1. OLCR-NLS-85/06 (Supplemental Submittal)

SUBJECT: Facility Operating License NPF-29, page 9.

2. (NPE-86/04)

3. (NPE-86/05)

REACTOR VESSEL PRESSURE VERSUS TIME AFTER BREAK, GRAND GULF  
MAIN STEAM BREAK (3.5 SQ.FT.), OUTSIDE THE CONTAINMENT, HPCS FAILURE

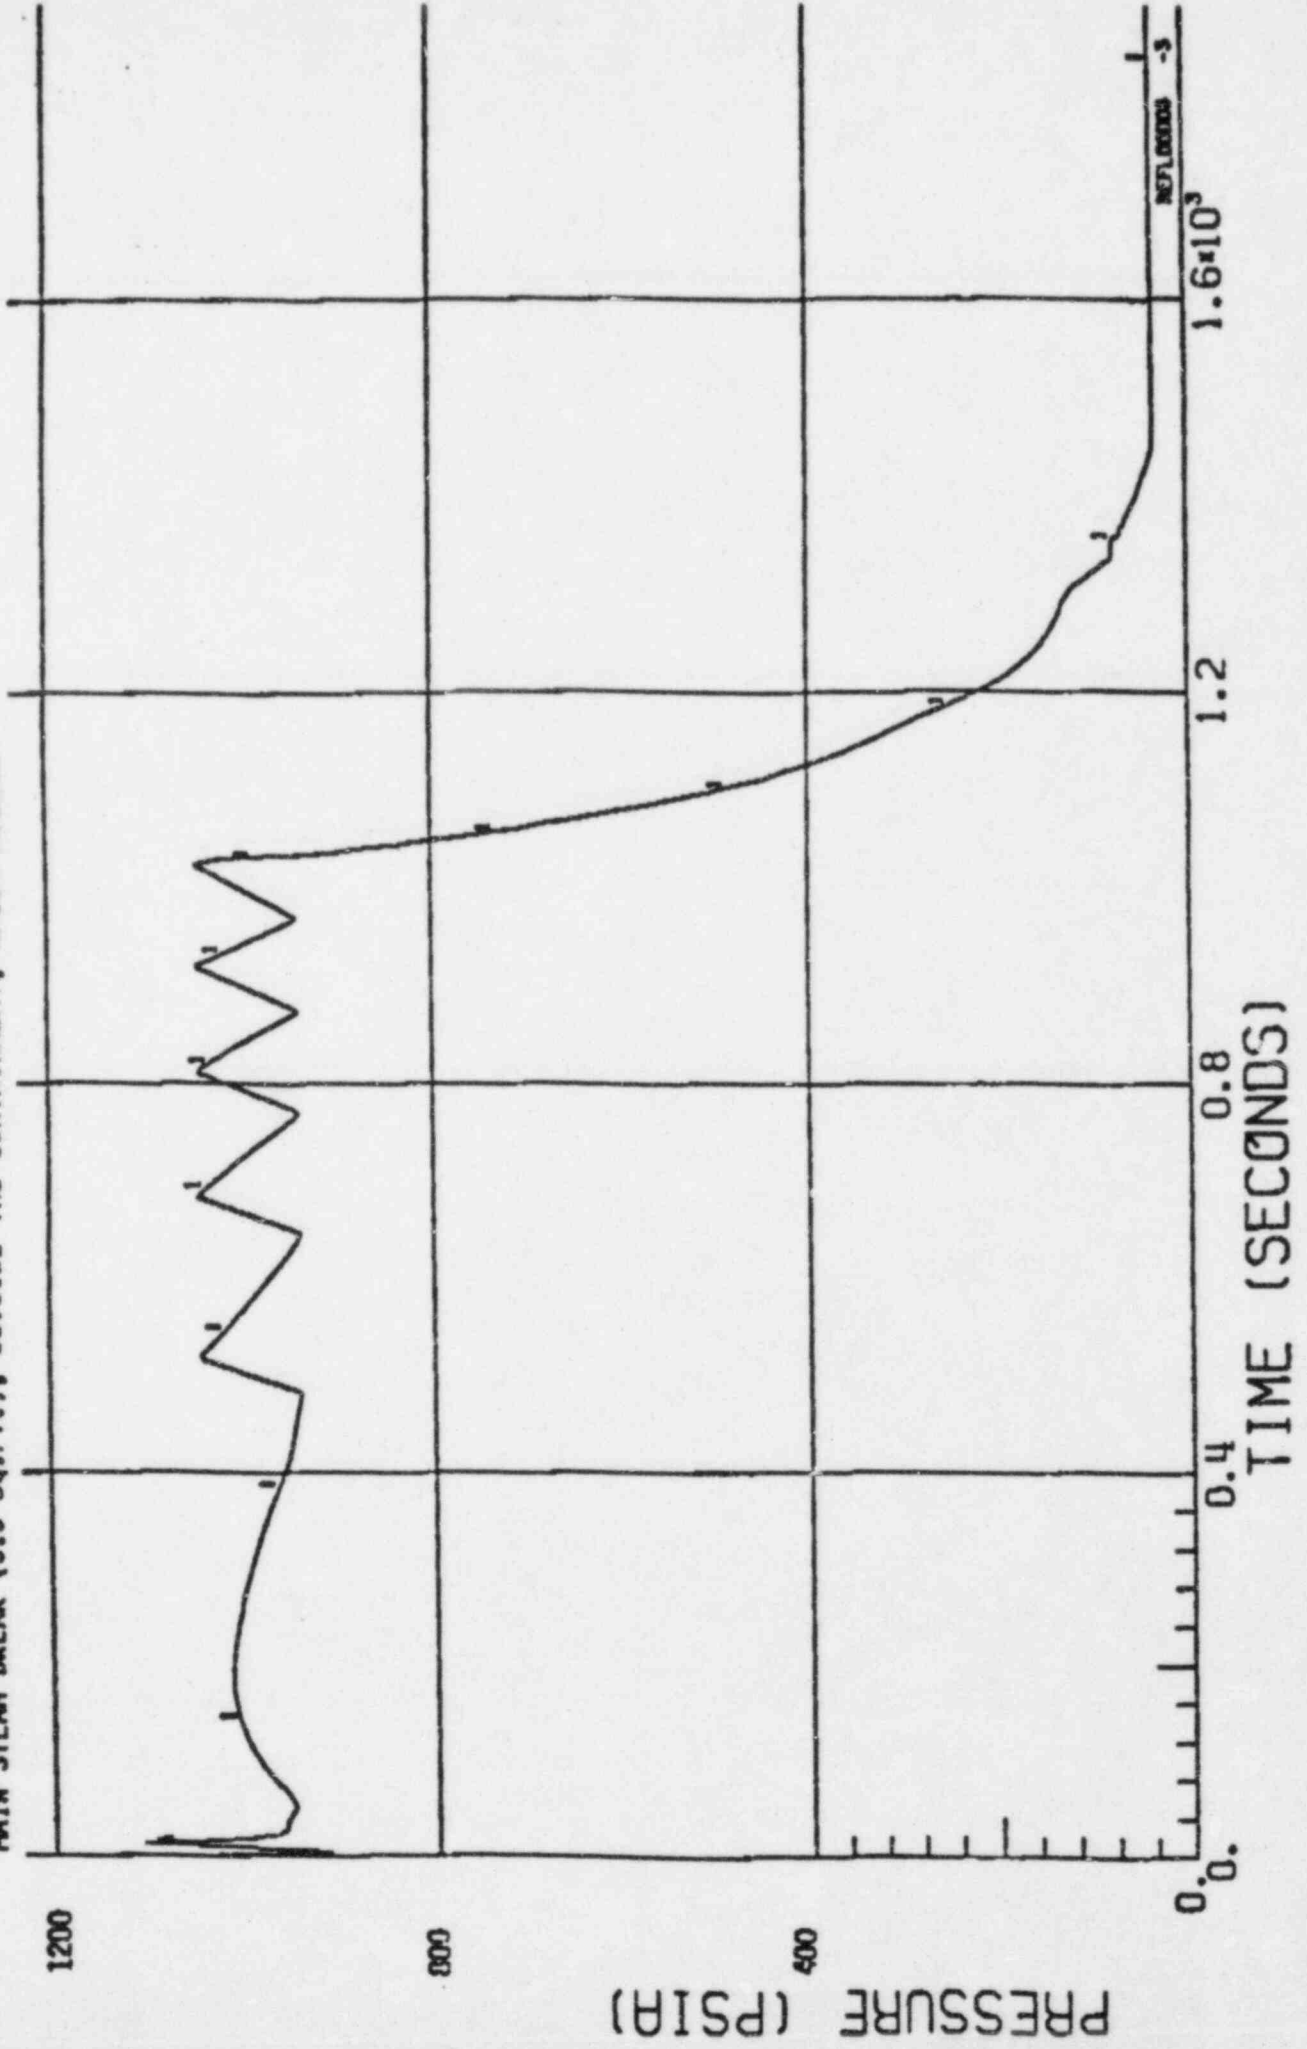
The upper analytical limit for the bypass timer delay setting was established based on the limiting ECCS event which does not result in a high drywell pressure trip. A review of the FSAR accident analyses determined that the limiting event is a main steam line break outside of containment assuming a high pressure core spray failure. Using a conservative maximum bypass timer delay setting of 10 minutes, a performance analysis resulted in a calculated fuel element peak cladding temperature (PCT) of 1862°F which is still well below the criteria of 2200°F as given in 10CFR50.46. The attached figures 1 through 4 document the results of the analysis and reflect the effects on system pressure, water level, heat transfer coefficients, and PCT.

- 1) involve a significant increase in the probability or consequences of an accident previously evaluated. The limiting accident analysis affected by this change is the steam line break outside of containment assuming HPCS failure. A reanalysis of this event determined that after the water level reaches Level 1 and with the maximum bypass timer setting of 10 minutes, a PCT of 1862°F would occur. This PCT is substantially below the criteria of 2200°F as given in 10CFR50.46. Further, the modifications result in an enhancement of the ADS and do not affect performance of the intended safety function. The modifications extend the automatic initiation of ADS to encompass those transient events which do not produce a high drywell pressure signal but may require depressurization of the reactor vessel to maintain adequate core cooling.

FIGURE 3  
 PEAK CLAD TEMPERATURE VERSUS TIME AFTER BREAK, GRID 20 GULF  
 MAIN STEAMLINE BREAK (3.5 SQ.FT.), OUTSIDE THE CONTAINMENT, NPCCS FAILURE

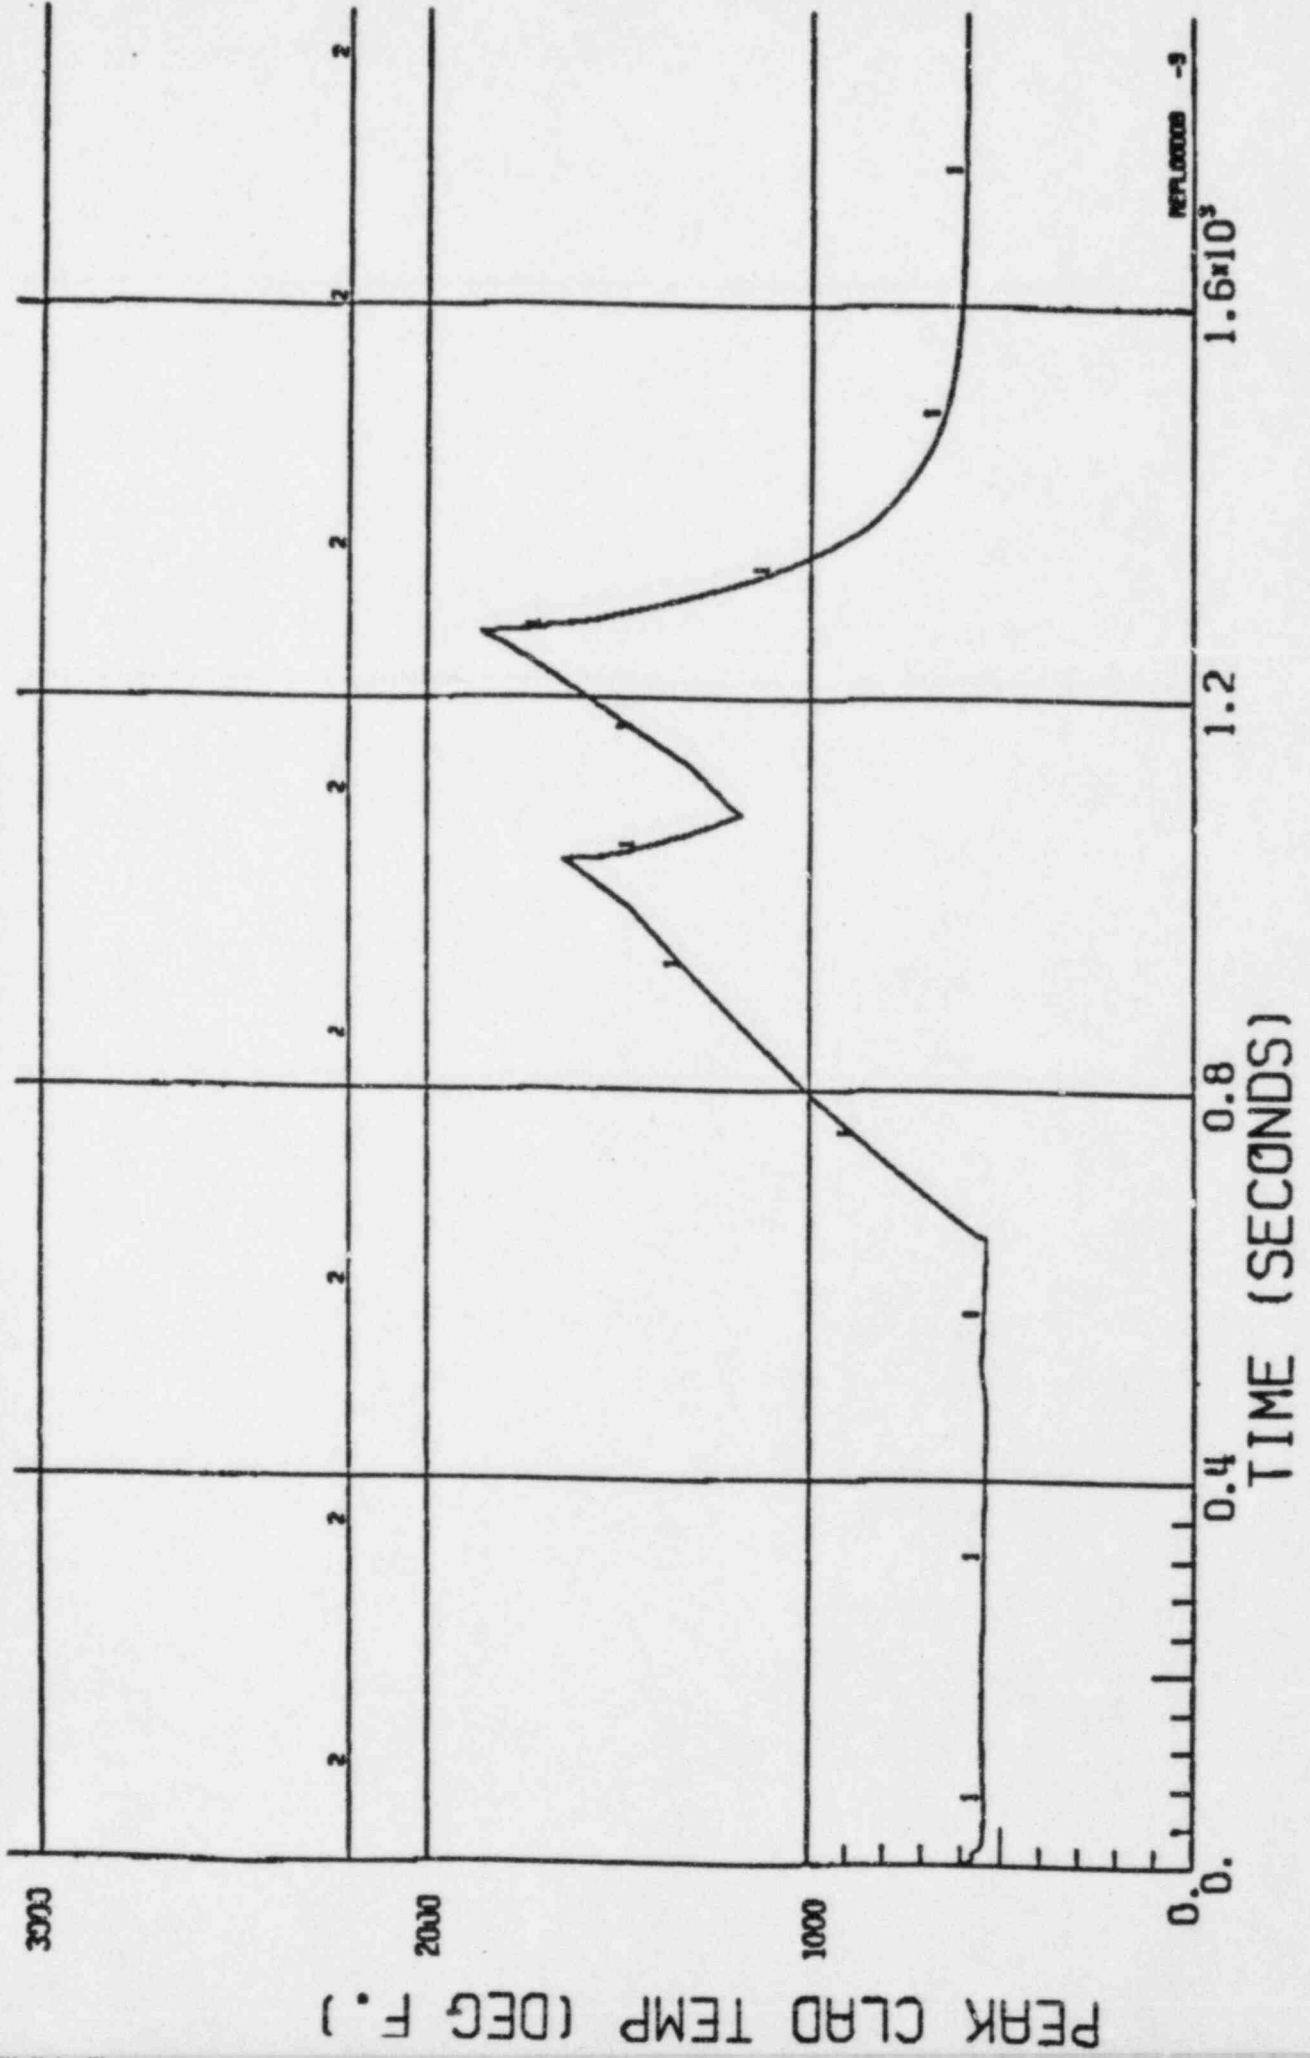
- 3) involve a significant reduction in a margin of safety because margins of safety are not adversely affected. The only margin of safety considered is the peak cladding temperature. The criterion of 2200°F as given in 10CFR50.46 is met with significant conservatism since the PCT for the limiting event is 1862°F. Further, the modifications eliminate the need for operator action for those events which do not produce a high drywell pressure signal but may require ADS actuation. Margins of safety are not affected by the lower limit for the bypass timer delay setting. This limit is determined only by the limiting ATWS event and will be a plant-specific ATWS feature unique to GGNS following ATWS modifications during the second refueling outage.

DEFINITIONS FOR  
 "CHANNELS", "TRIP SYSTEMS", AND "TRIP FUNCTIONS"  
 FOR EMERGENCY CORE COOLING SYSTEM ACTUATION INSTRUMENTATION TABLE 3.3.3-1 (Continued)

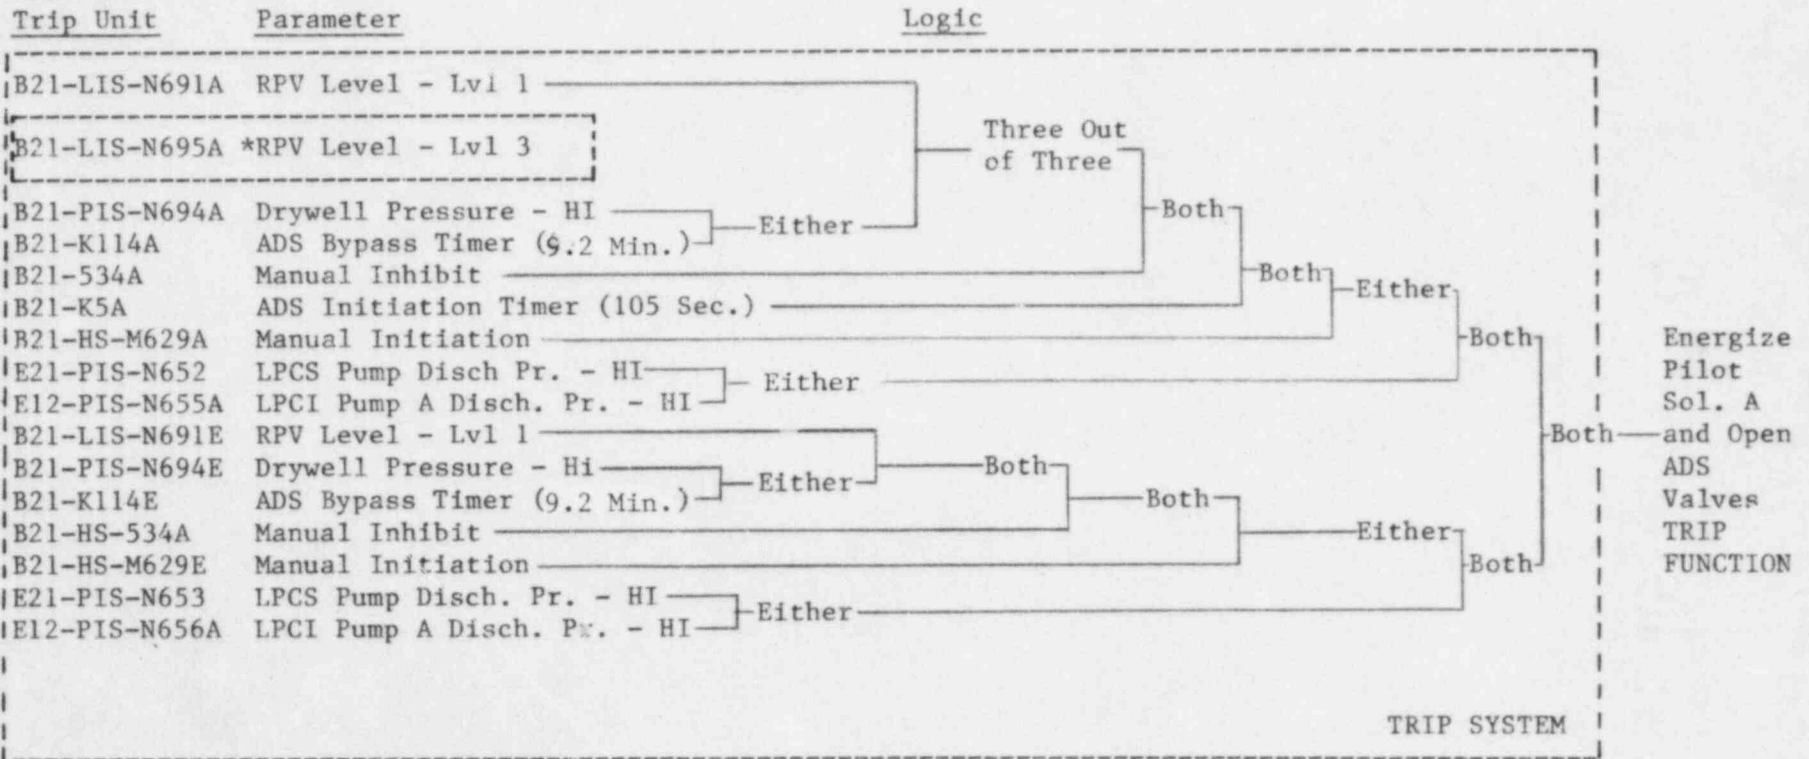
Attachment 1 to this submittal is an update to the logic diagrams for the Emergency Core Cooling System Actuation Instrumentation reflected in Table 3.3.1-1. These logics were originally submitted in a letter to Mr. Harold R. Denton from Larry F. Dale dated May 8, 1984 (AECM-84/0093).
